## APPROVAL FOR CONSTRUCTION

THE PLANS AND SPECIFICATIONS FOR SEWAGE

## APPROVAL NO OWNER: 17990 Subd. Appvl. No.: MADELINE MAILET EDUARDA/H TELHEIRO Registry Book No.: % 45 MACY ST APT 2030 Registry Page No.: 817 AMESBURY MA 01913 Probate Docket No.: COPY SENT TO: (If Applicable) Type of System: BUARD OF SELECTMEN TOWN OFFICE Town/City Location: SEABROOK SEABROOK NH 03874 Street Location: 88 BLACKSNAKE ROAD BY APPLICANT: PERMIT NO. Subsurface waste disposal systems must be operated and maintained in a manner so as to prevent nuisance or health hazard due to system failure. STOCKTON SERVICES PO BOX 1306 HAMPTON NH 03842 hydrocarbon solvents such as TCE, sometimes used to clean failed septic systems and auto parts. (Env-Ws ADVISE YOUR CONTRACTOR OF REQUIRED CHANGES IN PLANS AS INDICATED BELOW CONDITIONS SEPTIC SYSTEM APPROVED WITH MUNICIPAL WATER SUPPLY ONLY FOR A 3 BEDROOM HOUSE & A 1 BEDROOM APARTMENT ONLY. CONSERVING PLUMBING FIXTURES IS SUGGESTED. JOHN BAAS

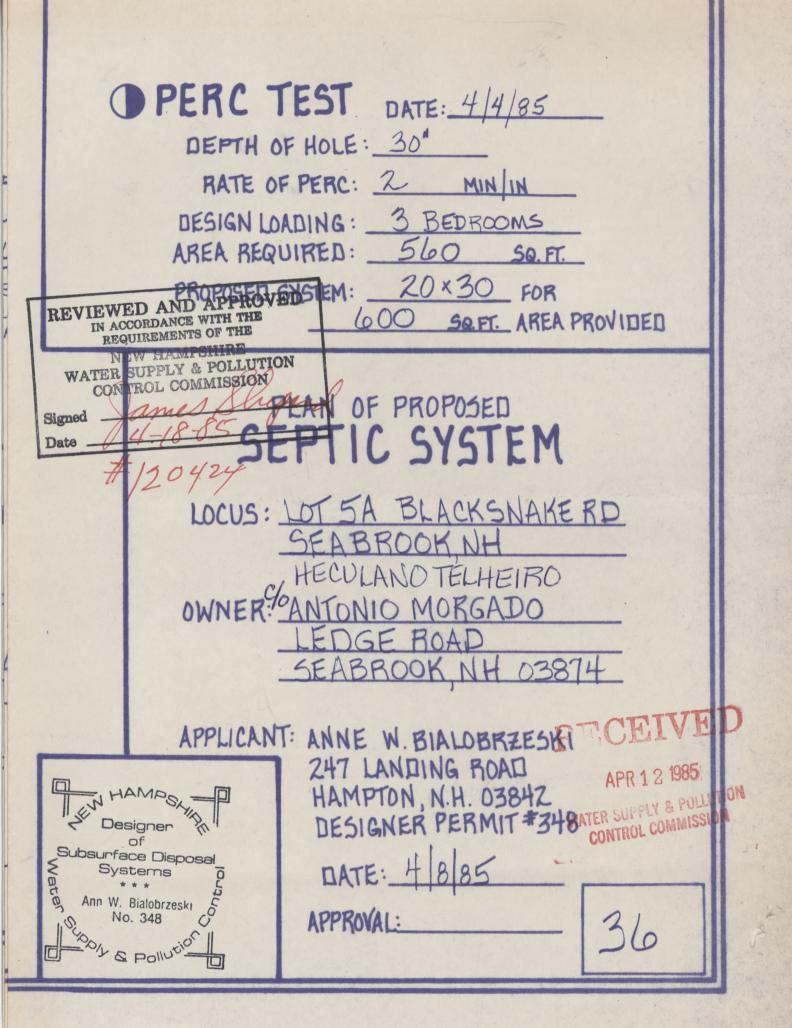
| 983<br>033  | OR WASTE DISPOSAL SYSTEM SUBMITTED FOR: |                                    |  | APPROVAL # 120424     |                        |  |  |
|---|---|------------------------------------|--|-----------------------|------------------------|--|--|
| NOTE: ( XX) Gravity system ( ) Gravity system to septic tank and effluent pump chamber  |   |                                    |  |                       |                        |  |  |
| with disposal system to be constructed on a properly prepared base.   |   |                                    |  |                       |                        |  |  |
| to maintain (XX ) no lower than the original grade  |   |                                    |  |                       |                        |  |  |
| to maintain (XX ) _4 _' minimum above (the reported) (xxxy) seasonal high water table.  |   |                                    |  |                       |                        |  |  |
| ( XX) Fill to prepare disposal area should be a medium to coarse sand (0.5 to 1.0 mm).  |   |                                    |  |                       |                        |  |  |
